<b>Topic</b>	Software Update   Window Short Drop Deletion   Continental GT/GTC   26MY (SC25 /31)
<b>Market area</b>	Bentley: worldwide (2WBE),China 796 VW Import Comp. Ltd (Vico), Beijing (6796)
<b>Brand</b>	Bentley
<b>Transaction No.</b>	2078277/22
<b>Campaign number</b>	ED59
<b>Note</b>	
<b>Type</b>	
<b>US code</b>

Software Update | Window Short Drop Deletion | Continental GT/GTC | 26MY  
(SC25/31)

Release date: Jan 6, 2026

Figure 10

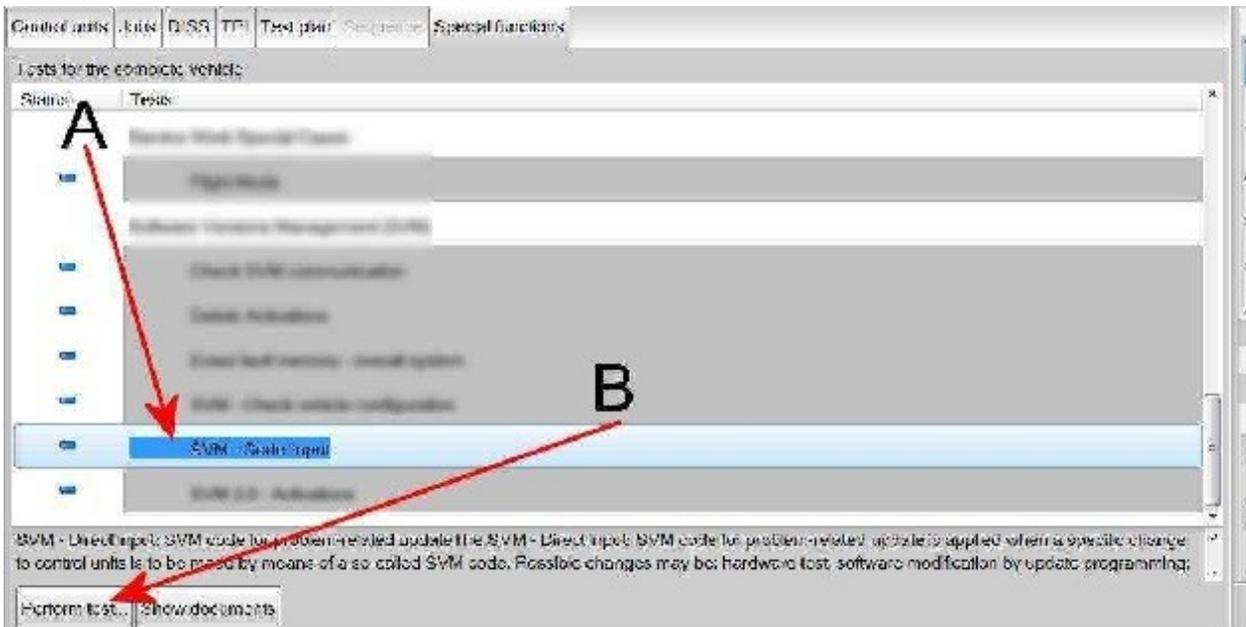
2) Referring to Figure 10 - Within the Special functions tab - Select SVM - Code Input (Point A)

• Select Perform test (Point B)

Figure 11

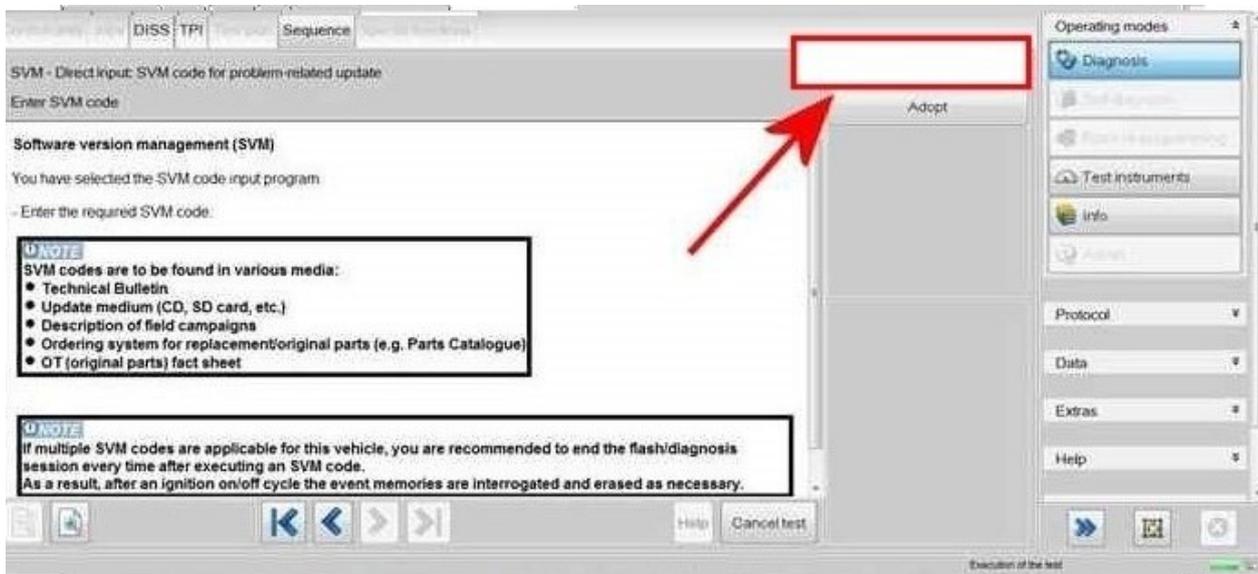
3) Referring to Figure 11 - Enter the SVM code **372WDD02**
